Edwin I. Hatch
Nuclear Plant - Unit 2

CORE OPERATING LIMITS REPORT
for
Operating Cycle 10

Revision 1

RE: Hatch Project Support - Licensing
Core Operating Limits Report for Hatch 2 Cycle 10, Revision 1
File: Fuel Cycle Technical
Log: HL-2368

FIGURE 3-2 MAPFAC_p

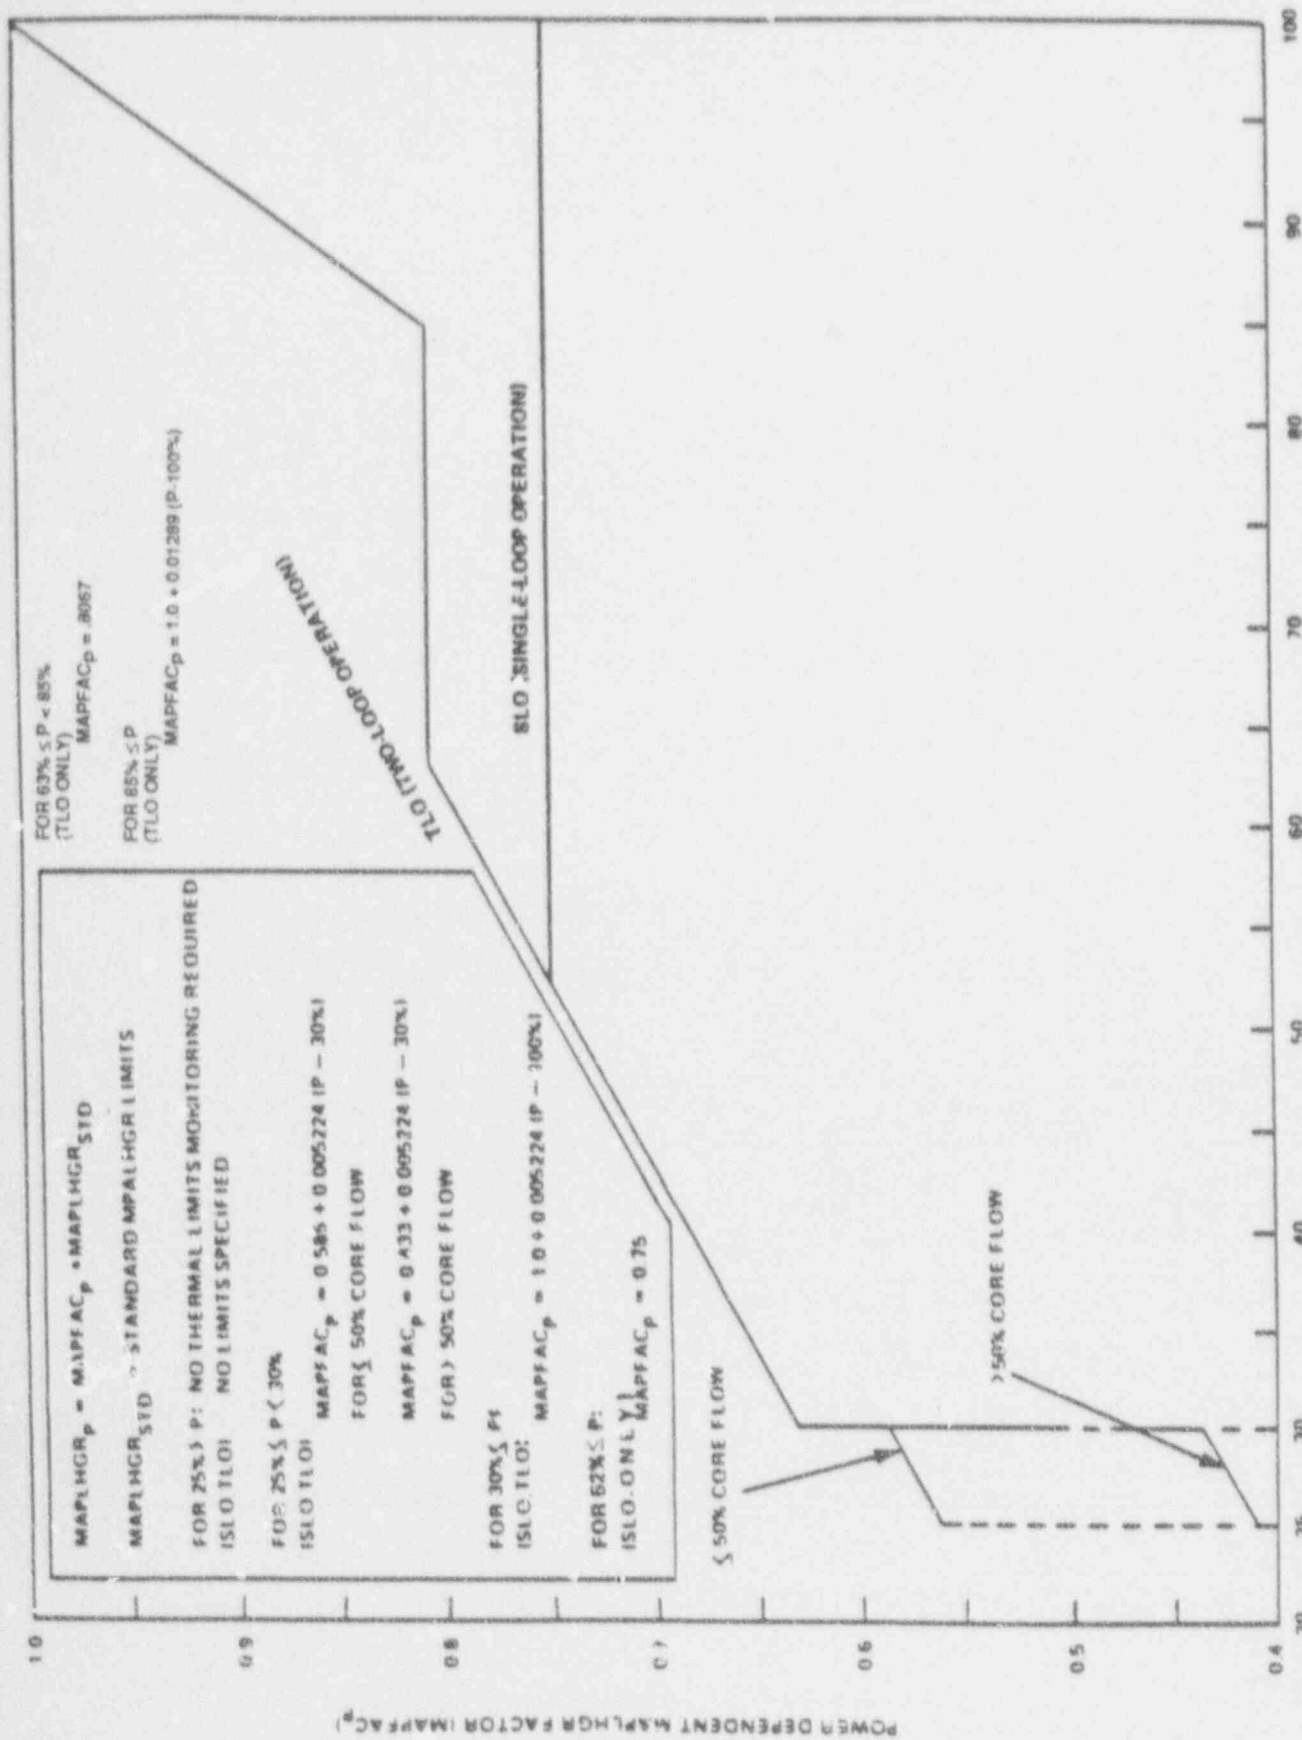
Enclosed is Revision 1 to the Plant Hatch Unit 2 Core Operating Limits Report (COLR) for Cycle 10 which imposes a Maximum Average Planar Linear Heat Generation Rate (MAPLHGR) penalty while operating above 63 percent of rated thermal power. The penalty was imposed in response to a concern related to the potential for a complete loss of feedwater heating. The MAPLHGR power factor (APFAC_p) graph in the COLR (Figure 3-2) has been revised accordingly. The concern is not applicable to Unit 1.
